# CITY OF ALBUQUERQUE

RE: **Lot 18, Blk 1 Cliffs Unit 22 SAD 228**  
**8019 Agua Fria Ct. NW**  
**Grading and Drainage Plan**  
**Engineers Stamp Date 10/29/2020 (D10D003N118)**  
**Pad Certification Date: 3/11/2021**

PROJECT NAME: PETROGLYPH ESTATES 8019 AGUA FRIA CT PULTE ID 18

SHEET TITLE: GRADING AND DRAINAGE PLAN

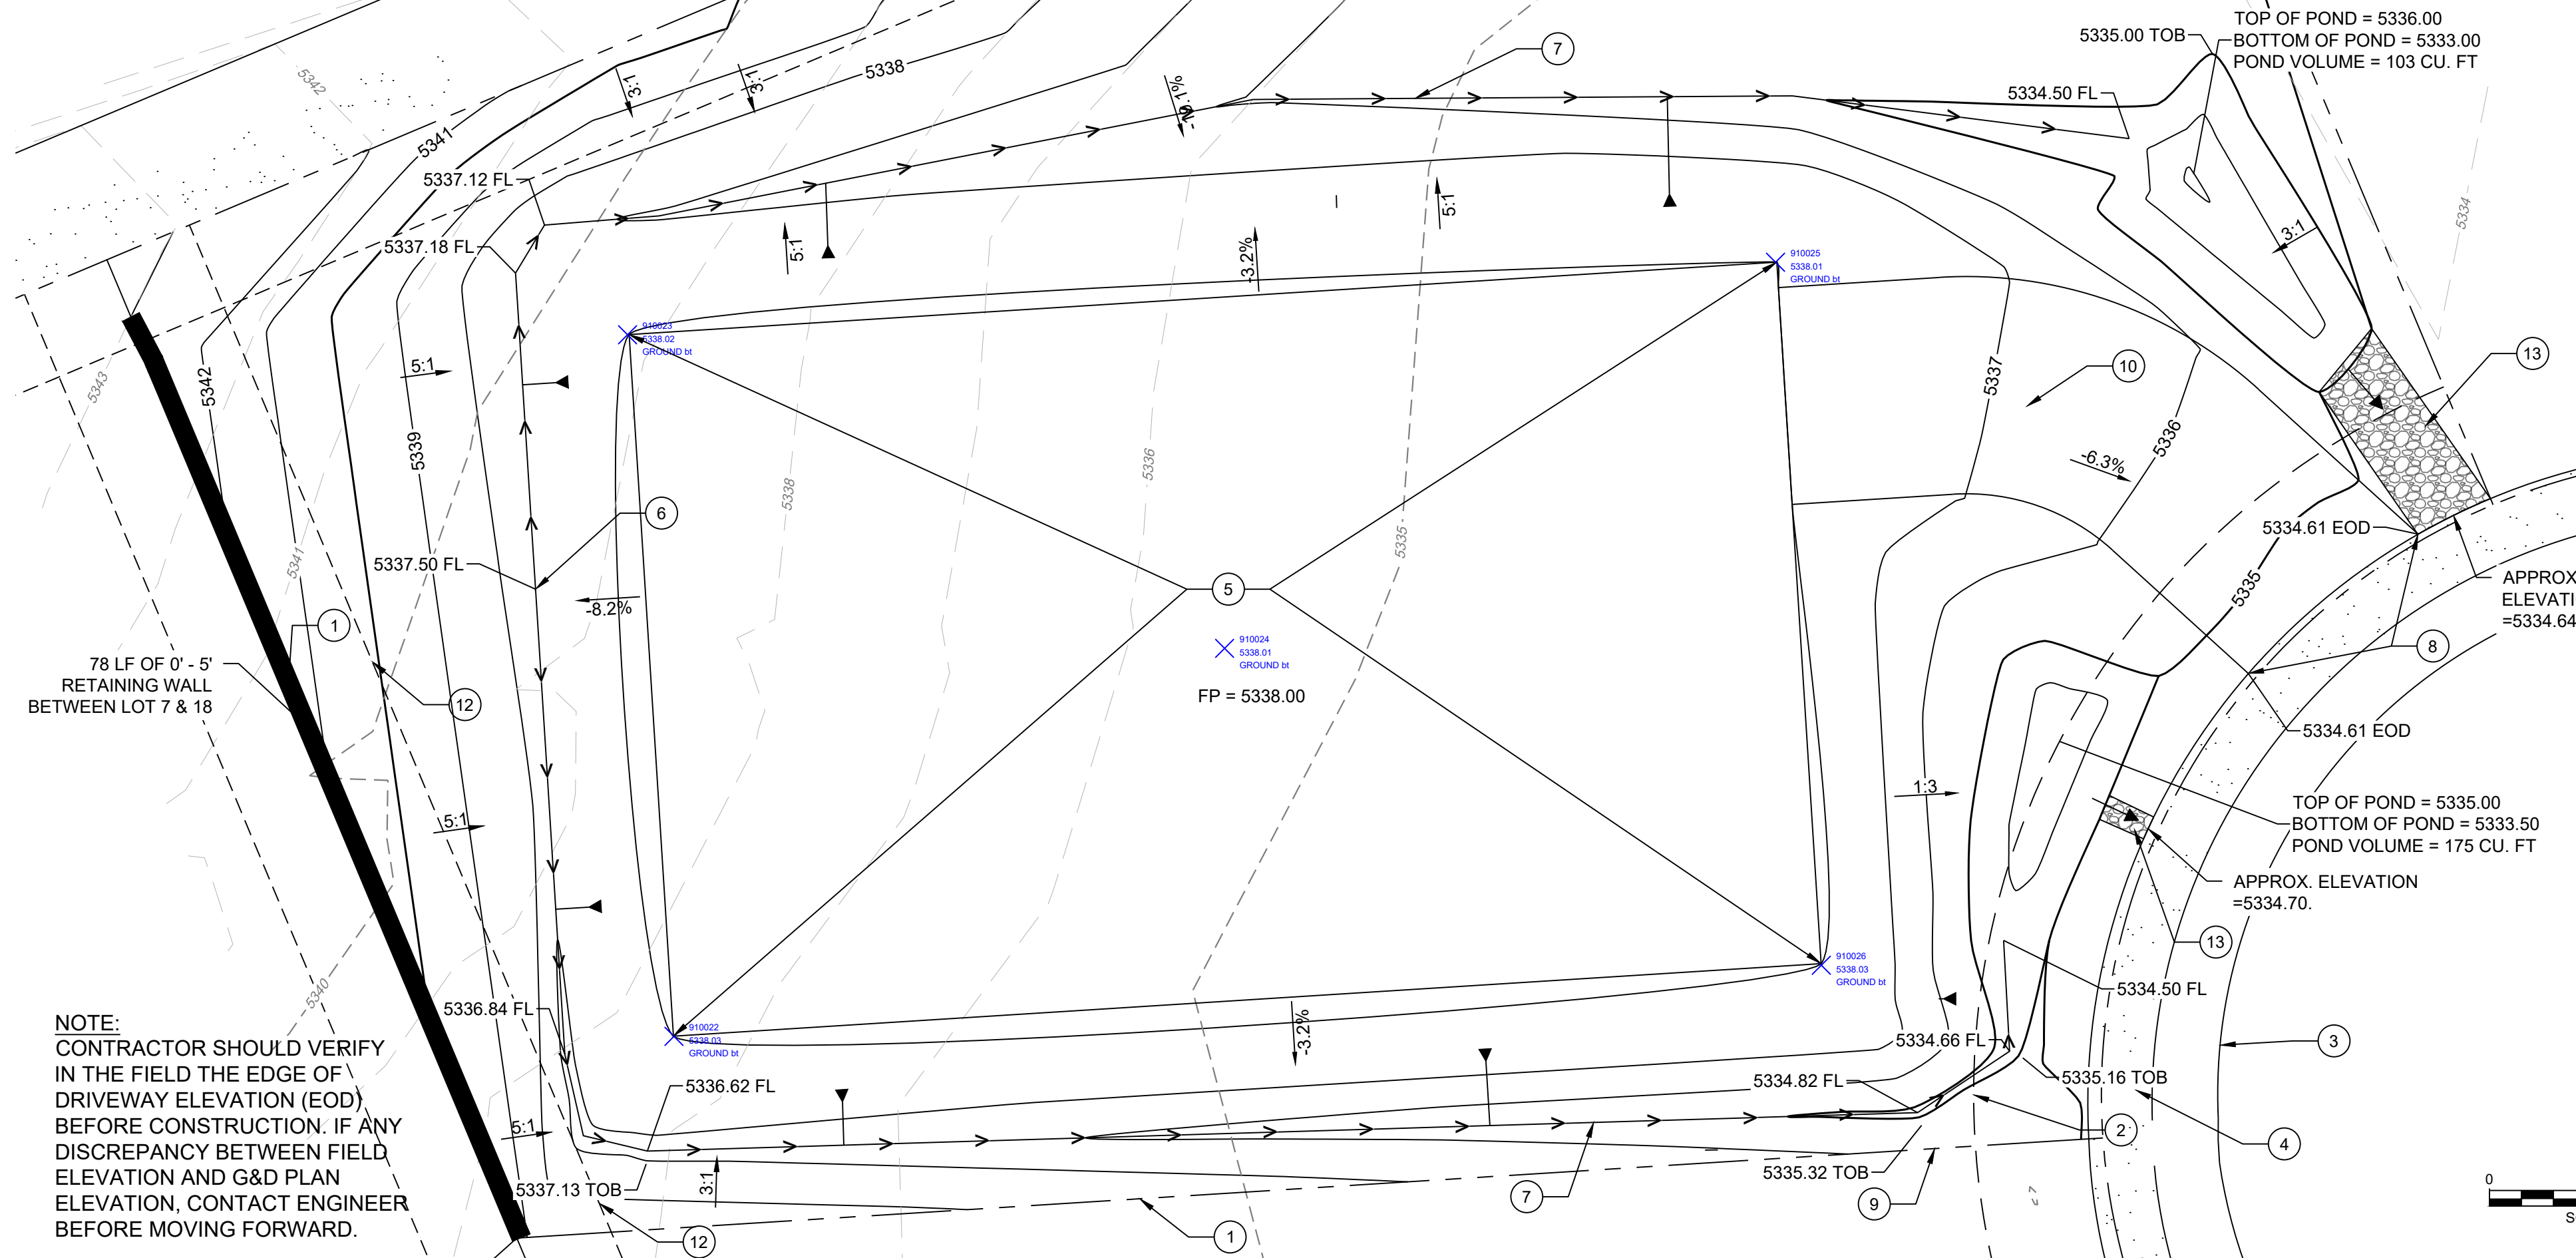
Based upon the information provided in your submittal received 4/19/2021, this plan is approved for Building Permit.

**Prior to Building permit approval a Pad Certification will be required, provided by the Engineer or a registered Land Surveyor.**

Reiterate to the Owner/Contractor that a separate permit for a garden/retaining wall must be obtained with the approved G&D plan and Pad Certification. **Also, if a swimming pool is to be placed the grading and drainage plan will change and will need to be resubmitted.**

**Prior to Certificate of Occupancy release, Engineer Certification per the DPM checklist will be required.**
